Work Order ID 105157

Item Name: Fwd Crosstube - High

DART AEROSPACE LTD	Work Order:	105157
Description: Crosstube High Fwd (205/212/412)	Part Number:	D212-664-101
Inspection Dwg: D212-664-141 Rev: D		Page 1 of 1

DRAWING NO. D212-664-141	TITLE XTUBE ASSY (205/212/412 HI FWD)	REV. D	DART AEROSPACE LTD ENGINEERING ORDER		D.E.O. NO. D212-664-141-D-1	SHEET NO. SHEET 1 OF 2	SCALE NTS
DRAWN	CHECKED	OP	MFG. APPR.	APPROVED	WAP	DE APPR.	
DATE 11.04.07	DATE 11.04.11		DATE 11.04.12	DATE 11/04/12		DATE 11.04.12

**D212-664-141/-141B
ASSEMBLY DETAIL**

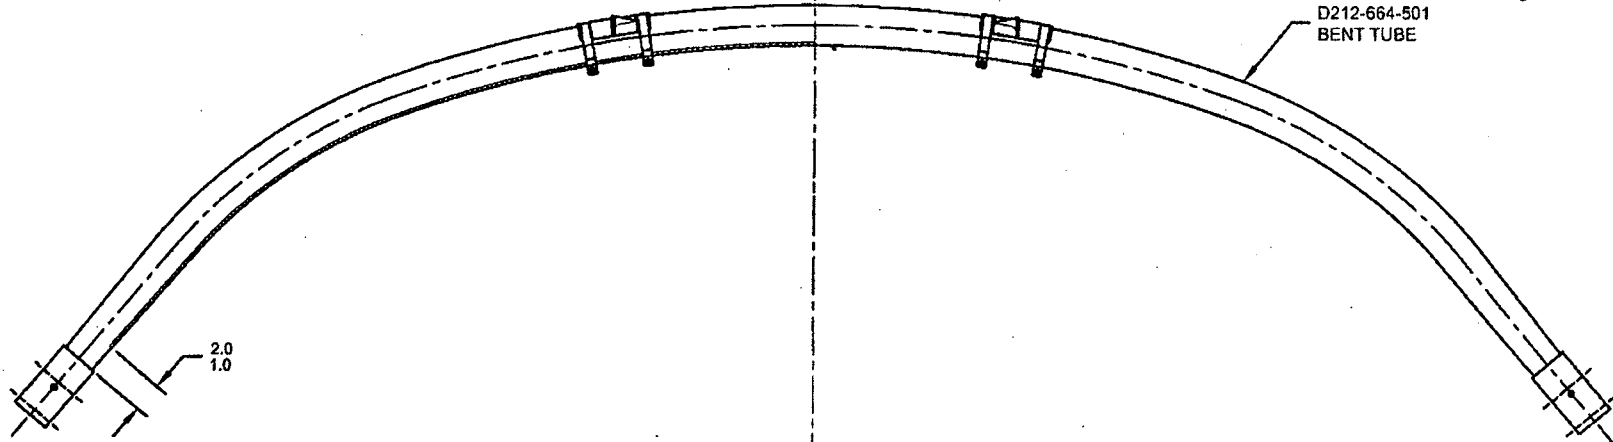
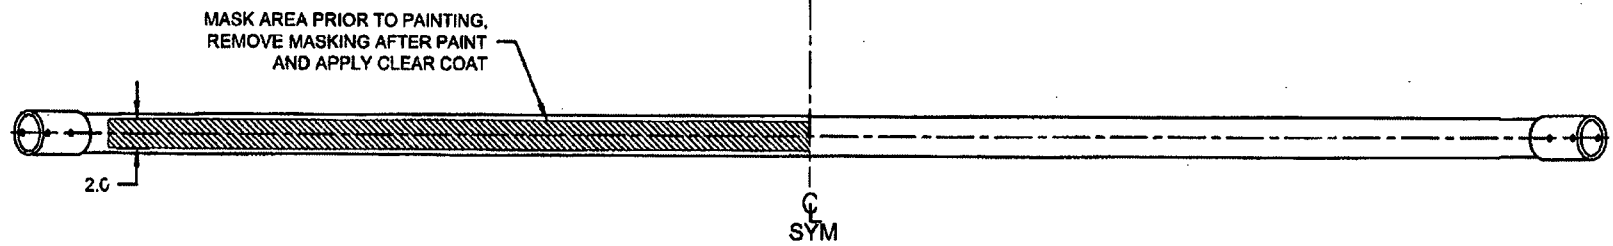
ADD AN INSPECTION WINDOW TO UNDERSIDE OF CROSSTUBE.

NOTES 2 OF SHEET 1 IS AMENDED AS FOLLOWS:

- 2) FINISH: CHEMICAL CONVERSION COAT PER DART QSI 005 4.1
PRIME INSIDE AND OUTSIDE PER DART QSI 005 4.2
MASK UNDERSIDE OF CROSSTUBE AS SHOWN (HATCHED AREA) AND
PAINT OUTSIDE PER DART QSI 005 4.2
REMOVE MASKING AND APPLY CLEAR COAT
